RAI 5:

Response to Request for Comment on Draft Safety Evaluation for AREVA Inc. Topical Report EMF-2328(P)(A), Revision 0, Supplement 1, Revision 0, "PWR Small Break LOCA Evaluation Model, S-RELAP5 Based" (TAC No. ME8227)

EMF-2328(NP)(A)
Revision 0
Supplement 1
Revision 0

PWR Small Break LOCA Evaluation Model,
S-RELAP5 Based

Figure 5-44: AFW Mass Flow Rate – CE 2x4

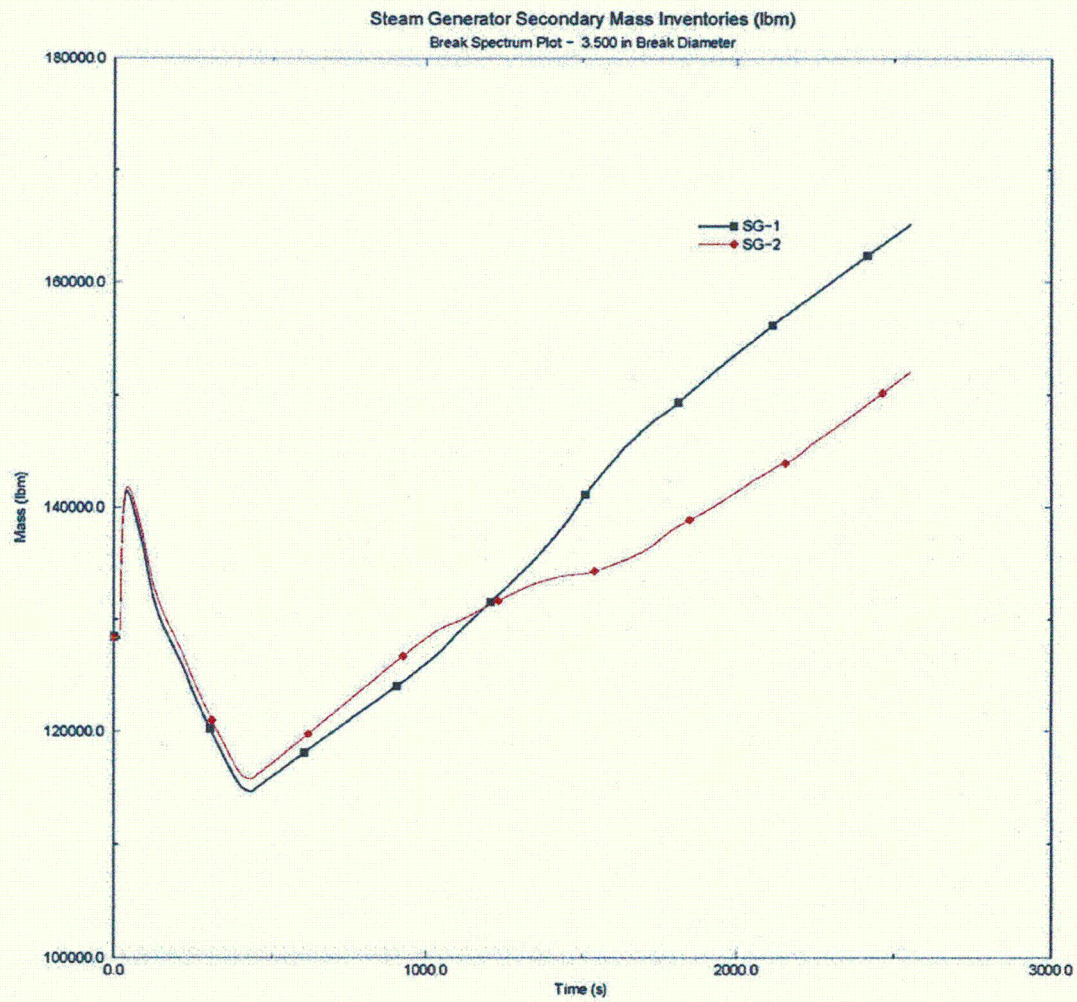
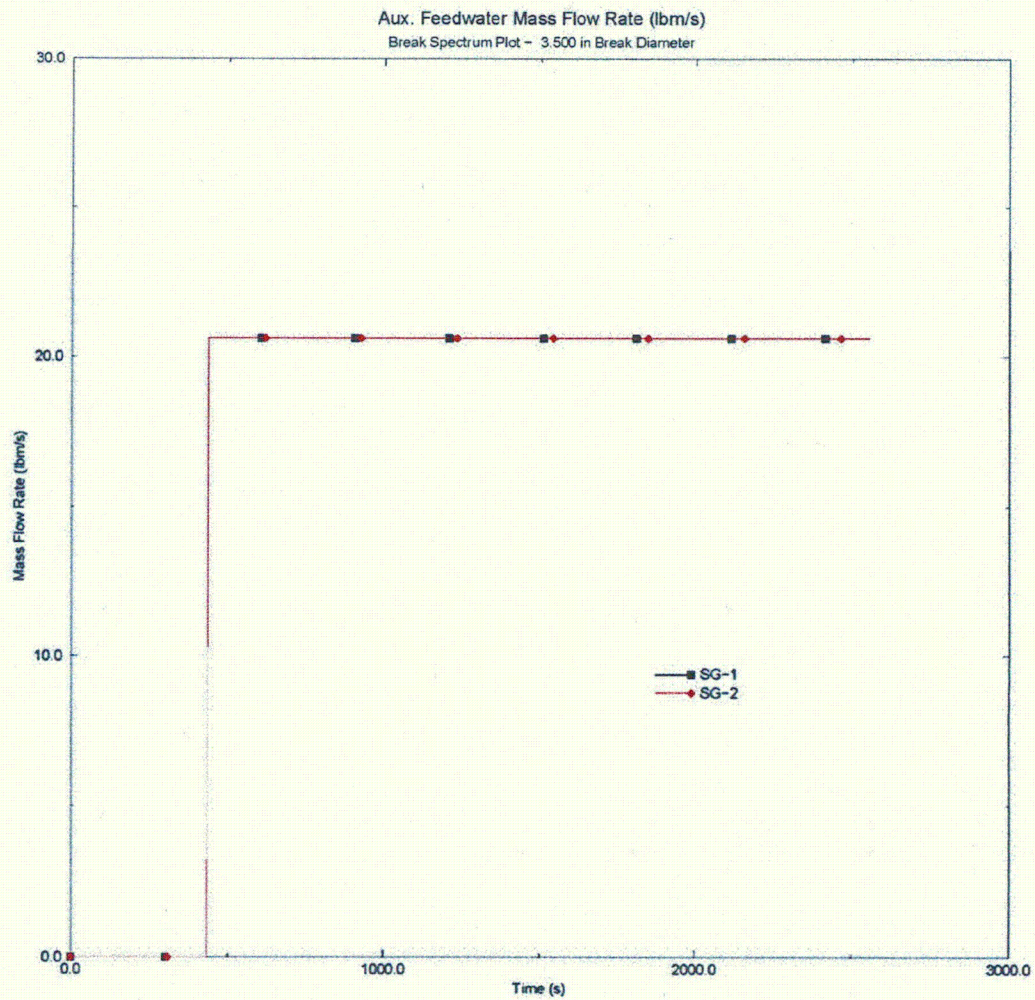
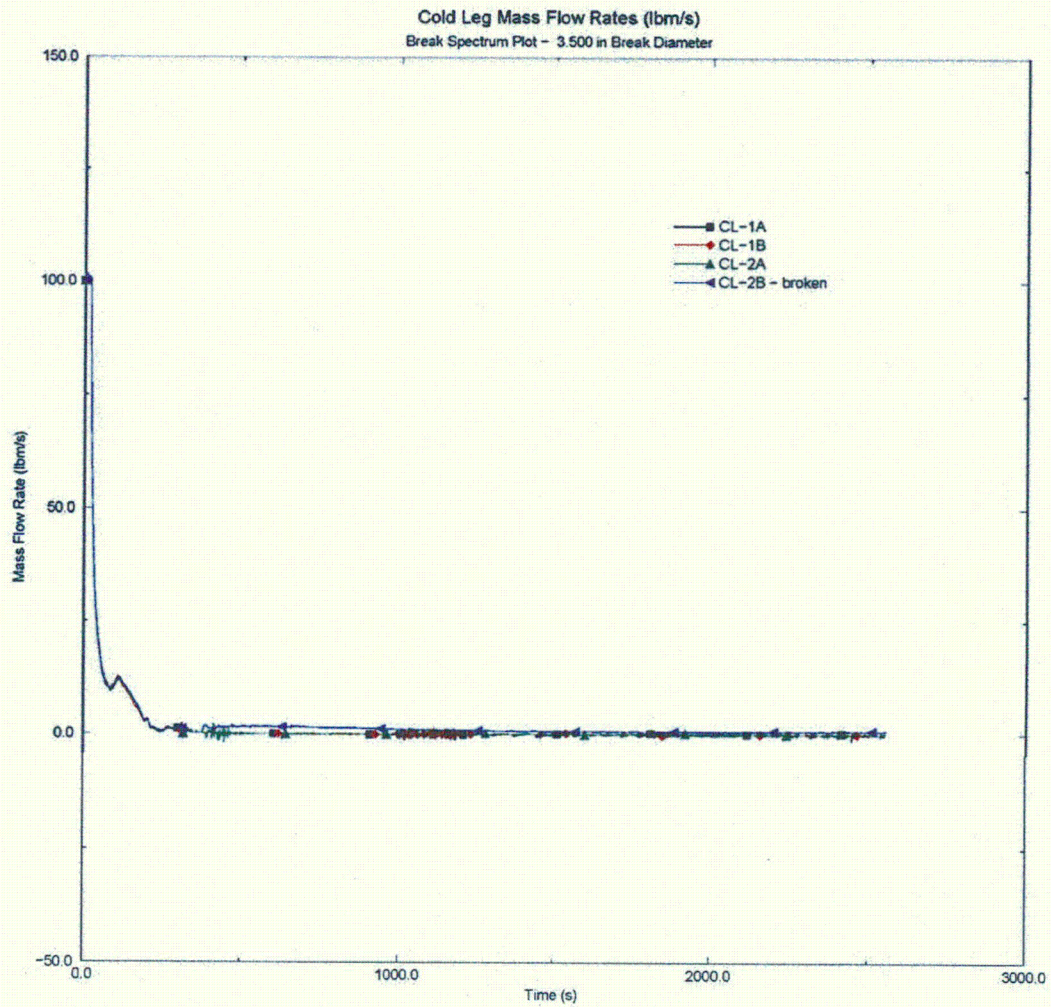
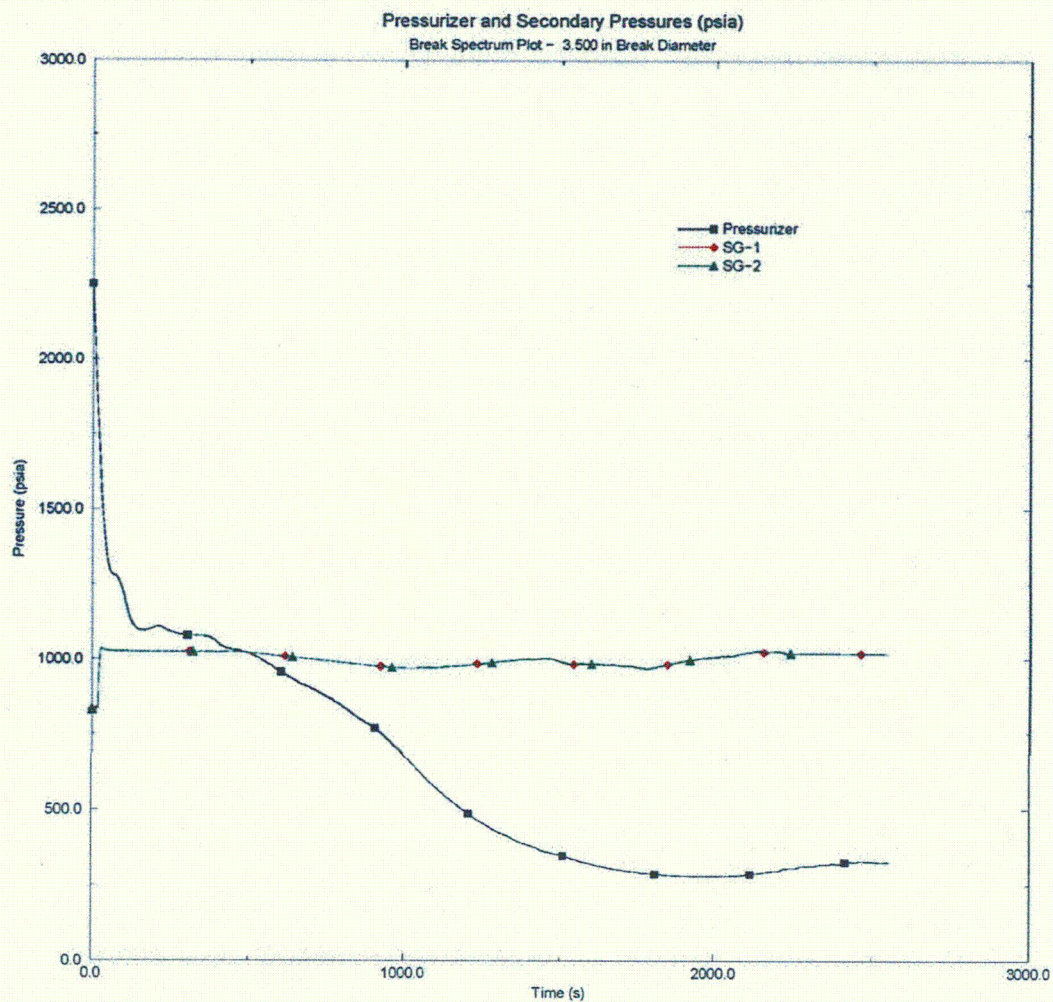
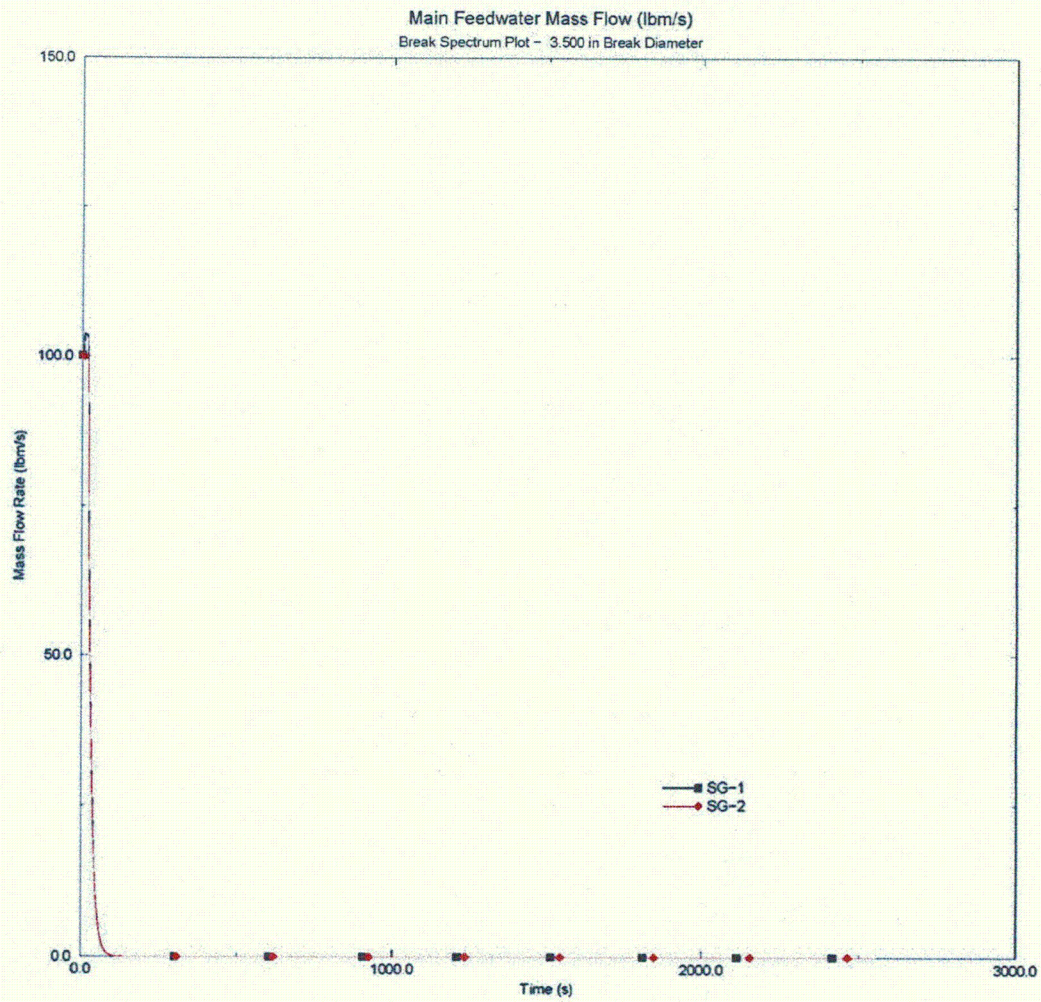
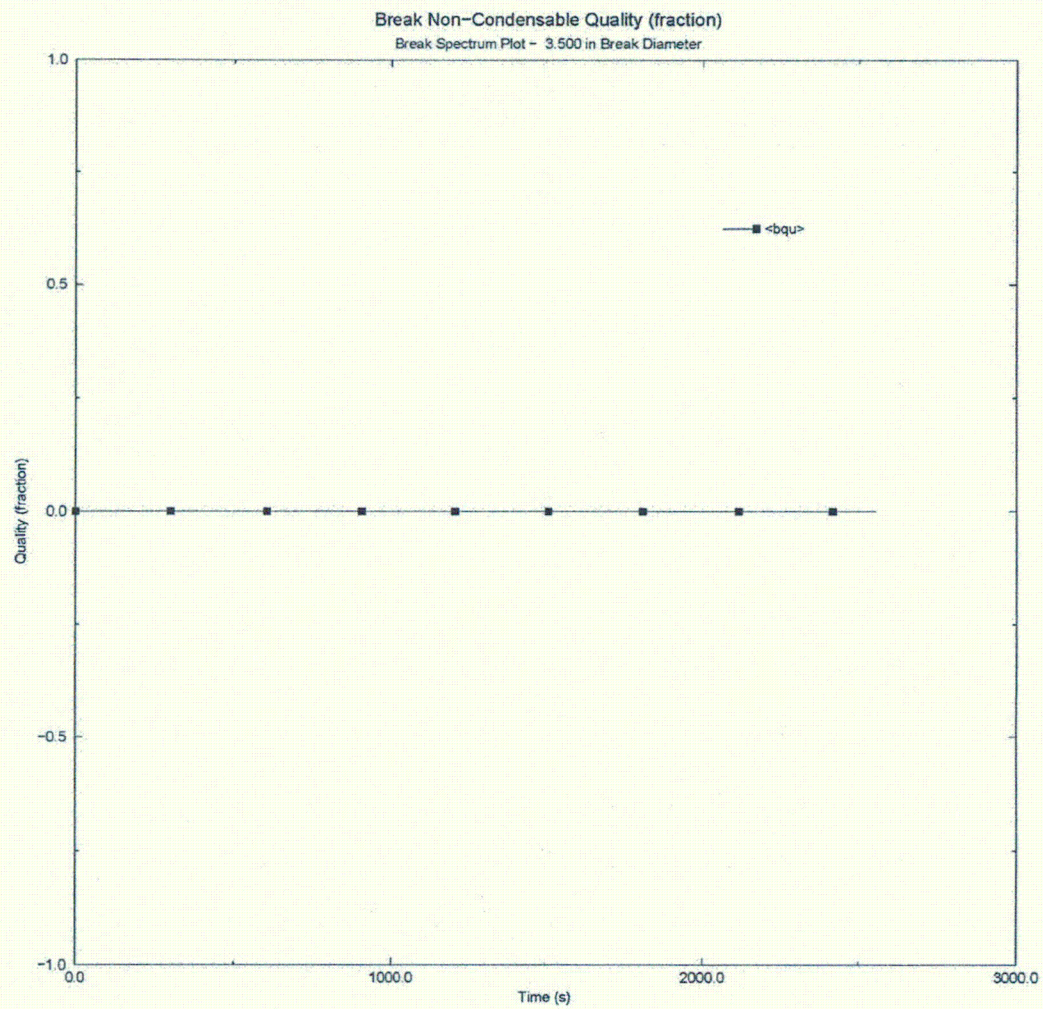
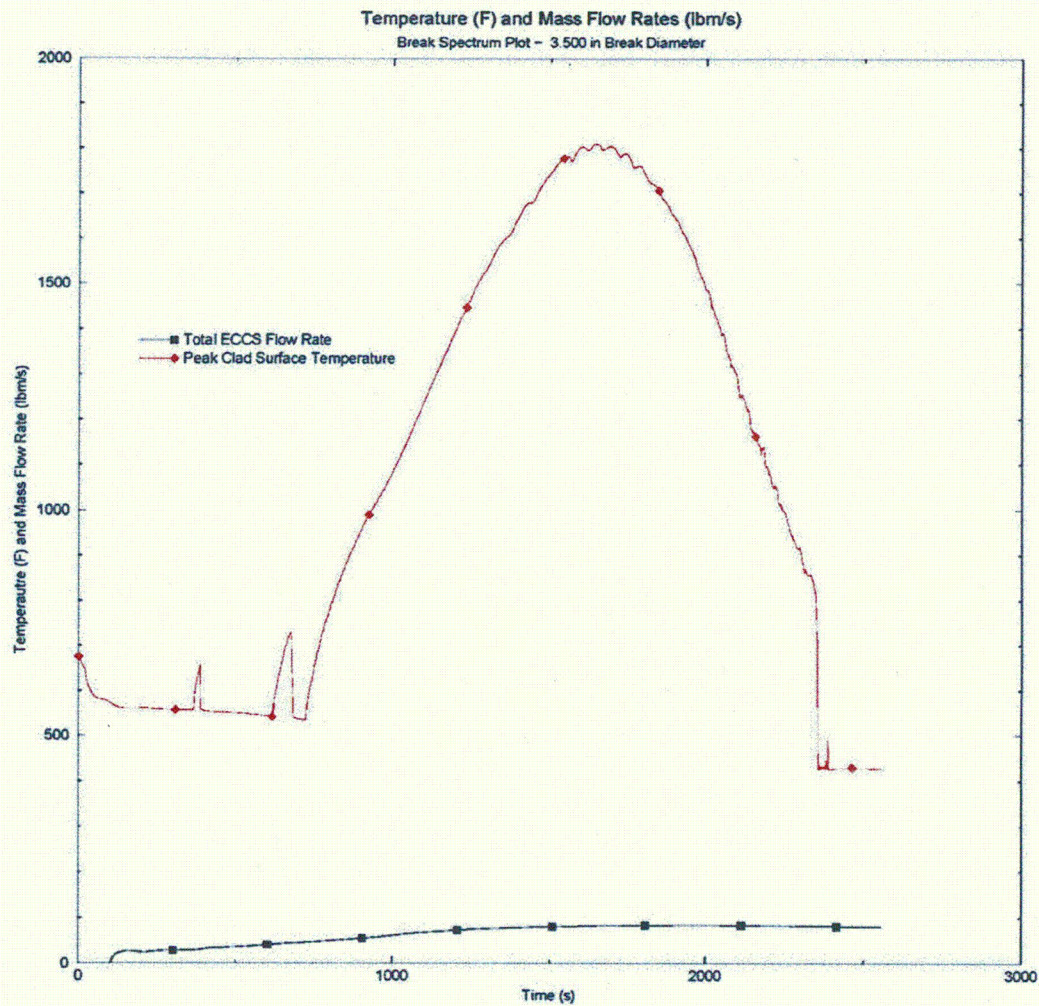
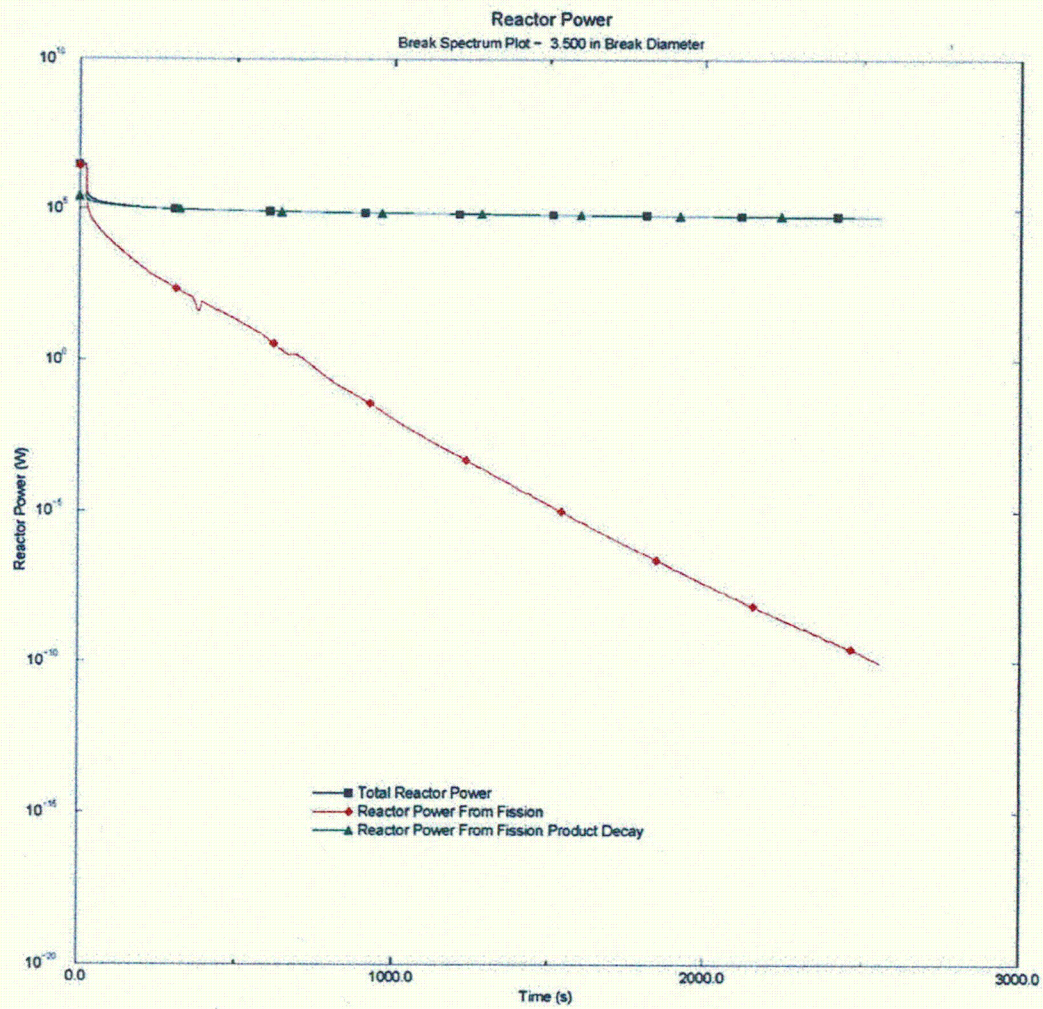
Please provide a plant sample break spectrum analysis with all of the EMF-2328(P)(A), Revision 0, Supplement 1, Revision 0, changes included. This could be accomplished by comparing the results of a sample plant SBLCOA spectrum with and without the EMF-2328(P)(A), Revision 0, Supplement 1, Revision 0, changes. This should include the severance of the safety injection line, as well.

The limiting break for a CLPD break and an SIT line break are presented in Table 5-11 and Table 5-12, respectively. The results from the break spectrum analysis are presented in Table 5-13. The limiting PCT is 1831°F for a 3.50 inch equivalent pipe diameter break size. A listing of the sequence of events for each break size in the spectrum is shown in Table 5-14a through Table 5-14d. Plots of some of the more important parameters for the limiting break of 3.50 inches are presented in Figure 5-35 through Figure 5-50.

A double ended break in the SIT piping connecting to the RCS does not produce a limiting case. An acceptable amount of emergency core cooling flow is delivered to the intact loops.

Figure 5-51: High Pressure Safety Injection Curve for CE 2x4 Sample Problem

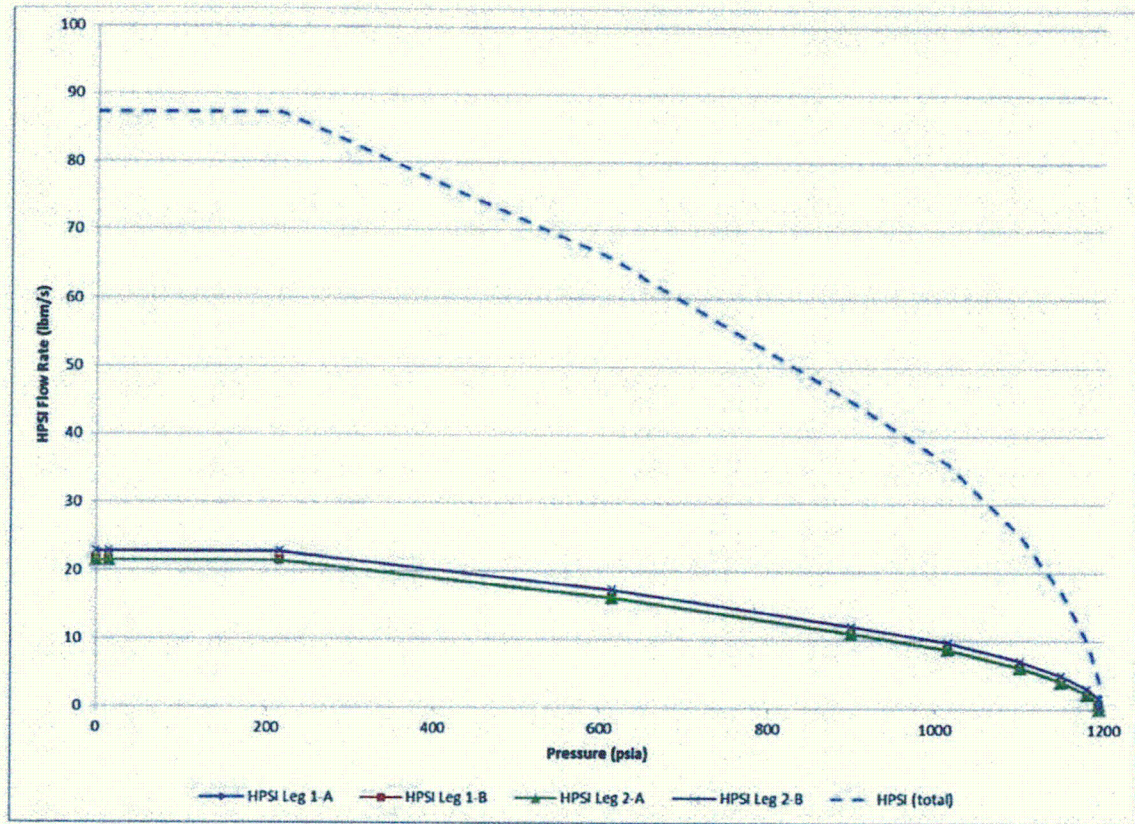
The high pressure safety injection (HPSI) pump performance was for the CE 2x4 sample problem was requested in discussions with the NRC. The HPSI pump performance curve used in the CE 2x4 sample problem is presented in Figure 5-51.
